Proposal for Supplement 2 to the 02 series of amendments to Regulation No. 129

Submitted by the expert from France*

The text reproduced below was prepared by the expert from France, on behalf of the informal group on Child Restraints Systems and updates the latest version of Regulation No 129. The modifications to the current text of the UN Regulation are marked in bold for new or strikethrough for deleted characters. **This document supersedes ECE/TRANS/WP.29/GRSP/2017/16. It includes all proposals of modifications made by the IWG ECRS during the three last meetings (2017/01/25, 2017/03/09 and 2017/04/19.**

Figure 2
Arrangement for testing a rearward-facing device, not supported by the dashboard

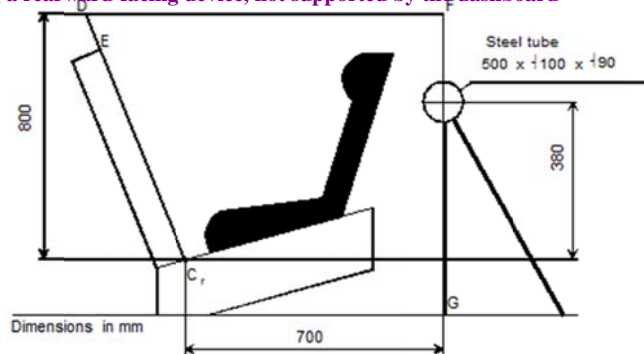
6.6.4.1.2.1. Head excursion: no part of the head of the dummy shall pass beyond the planes FD, FG and DE, as shown in figure 2 below. This shall be judged up to 300 ms or the moment that the dummy has come to a definitive standstill whatever occurs first.

Except when testing using Q6 dummy where:

- a) The value in relation to the FD plane is 840 mm

Where a test is conducted with paragraph 6.6.4.1.6.2. or paragraph 6.6.4.1.8.2. above, only the second configuration test results without 100 mm diameter bar will be considered.

A vertical displacement of 840 mm. should be accepted for all dummies, since it's already accepted for the Q10 dummy.

Figure 1.

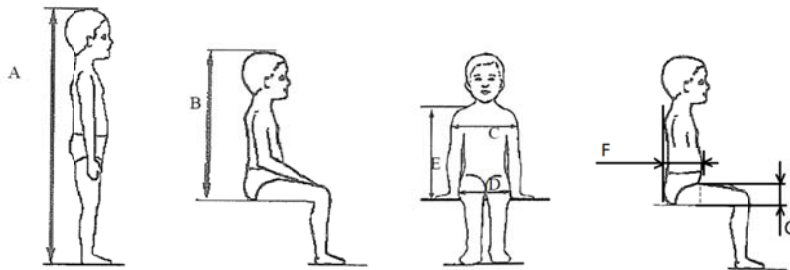
All lateral dimensions are measured under a contact force of 50 N with the devices described in Figure 2 & Figure 3 of this annex and the following tolerances will be applied:

Minimum Sitting height:

- up to 87 cm B - 5 per cent

- From stature from 87 cm and up to 150 cm B - 10 per cent,

Minimum shoulder height (5 percentile): $E1_{-2}^{+0}$ cm

Maximum shoulder height (95 percentile): $E2_{-0}^{+2}$ cm

The mass of the devices described in Figure 2 & Figure 3 of this annex shall be 10 kg +/- 1 kg
